**APPENDIX 1**

**PUBLIC CONSULTATION MATERIAL**

**MUNICIPAL CLASS ENVIRONMENTAL ASSESSMENT FOR THE VILLAGE OF ALTON  
MAIN STREET NORTH & QUEEN STREET WEST**

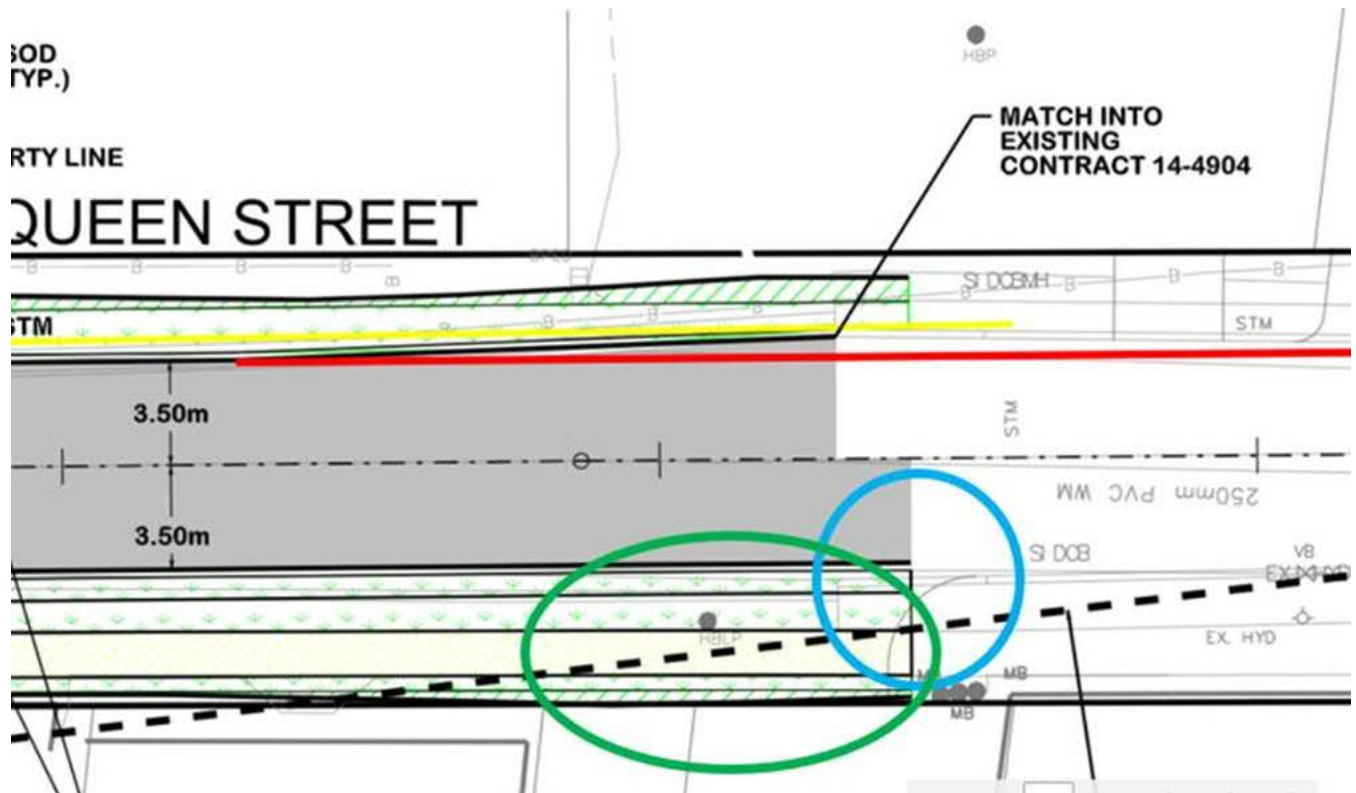
- c) This leads me to benches: we provided numerous alternatives to the community on benches. At that time, the community decided not to use wood surface benches due to maintenance and potential vandalism. I see the study suggest to use wood surface benches. Something to think about.

**Response: The benches provided (if any) will be determined in detailed design, and this suggestion will be taken into consideration.**

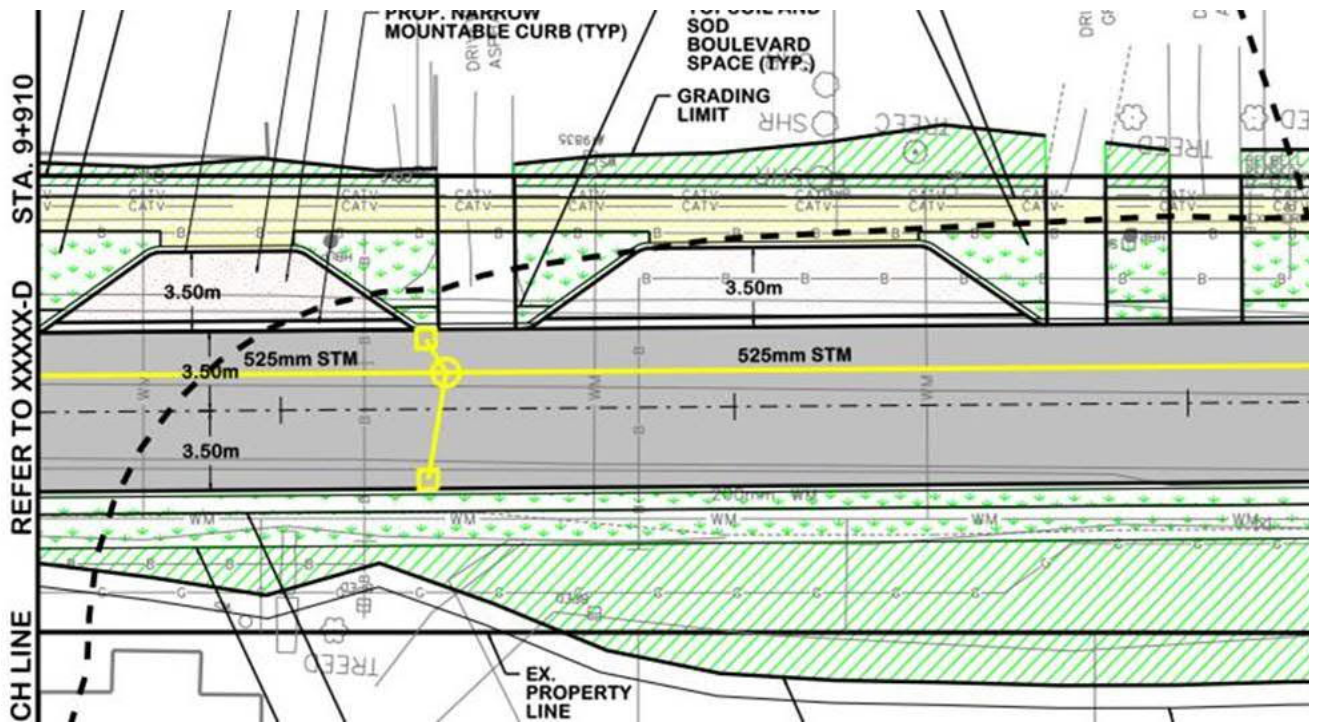
- b) I did not see in the proposed design any infiltration chambers and all proposed storm sewers simply outlet into existing creek or connect to existing storm manholes.

Response: Detailed sewer configuration will be determined in detailed design. Layout provided in the preferred alternative was selected in an effort to address functional needs for drainage improvements while also considering economic viability of the work. Double side inlet catch basins require larger manhole structures, resulting in higher capital costs. This will be reviewed in the detailed design stage while also considering the construction capital budget for the project.

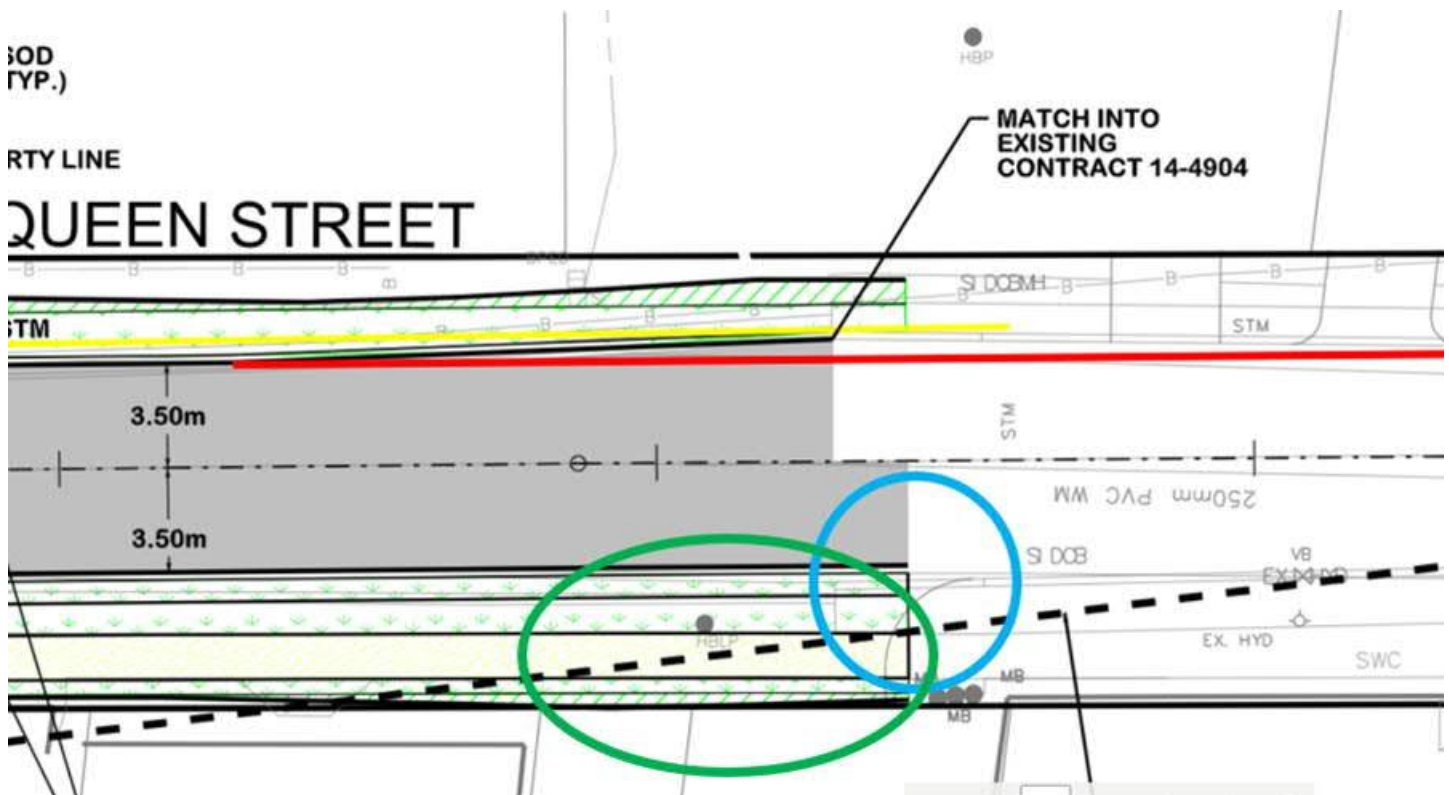
1. Rehabilitation of Main Street Bridge:
  - a) The comment I provided in my previous review requested the Town to look into widening of the West side sidewalk. You will be rehabilitating the entire bridge at \$1.25M and may want to consider adding extra platform-sidewalk for observation, winter maintenance storage, etc. I am not sure if you know but the N/W corner property of Main and Queen is currently up for sale. There are two lots there. The lot closest to the

intersection is up for development. As soon as the development application is filed, the Region will be seeking 15x15 daylight triangle. It's important to connect the bridge to the N/W corner of the intersection with a sidewalk as we witnessed residents crossing Main St N at the bridge, from East to West. According to the copies of the comments, numerous residents were also of support to add sidewalks on the bridge.

3. Storm sewer:

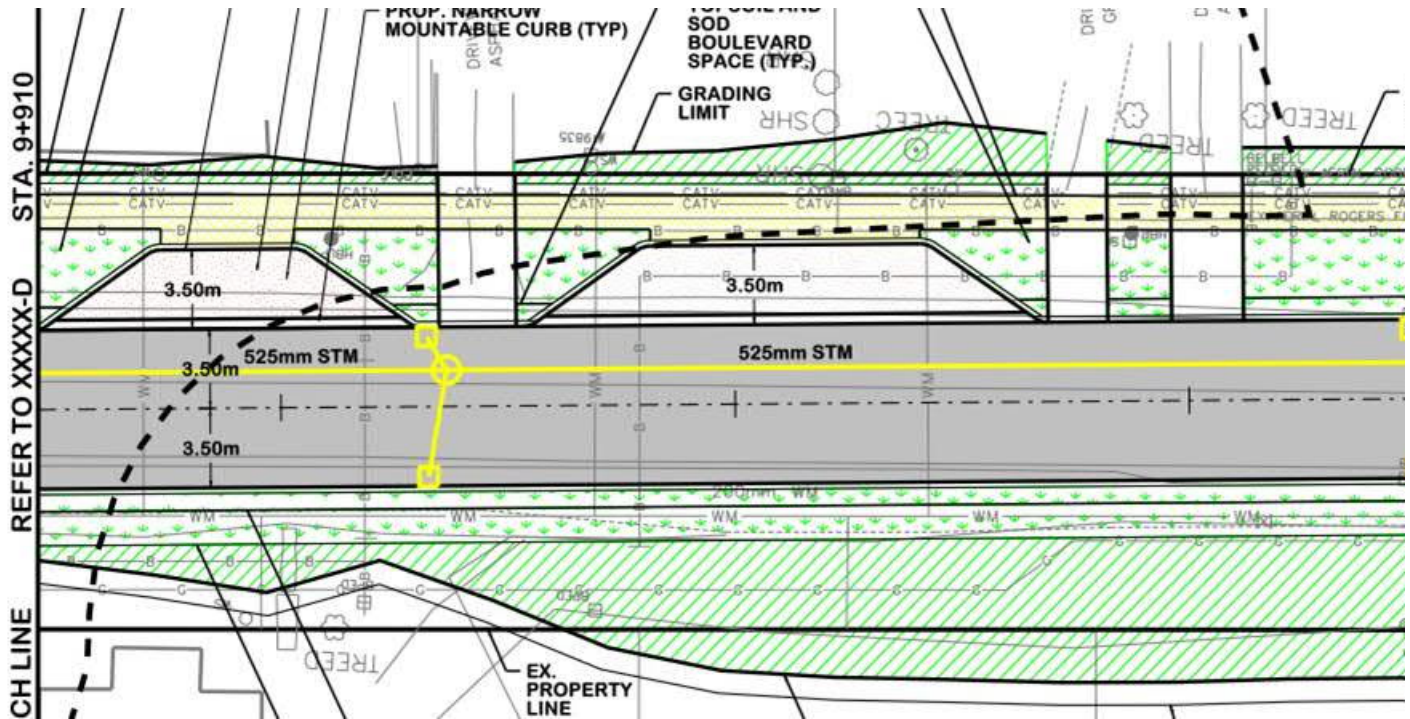
- a) My suggestion and similar to the comment in my previous review, due to tight ROW, would be to use side inlet CBs and avoid installation of main line storm sewers, where possible, in the middle of the lanes, which are too narrow. You are proposing to have cycling infrastructure and regular CBs in close proximity to MHs are not ideal for this. Also, even though the proposed MHs are drawn in the middle of the lanes, the installation of them will not be exact and the frames may end up under the wheel path, either left or right. This will be an issue for future maintenance and access, let alone the noise.
- b) I did not see in the proposed design any infiltration chambers and all proposed storm sewers simply outlet into existing creek or connect to existing storm manholes.
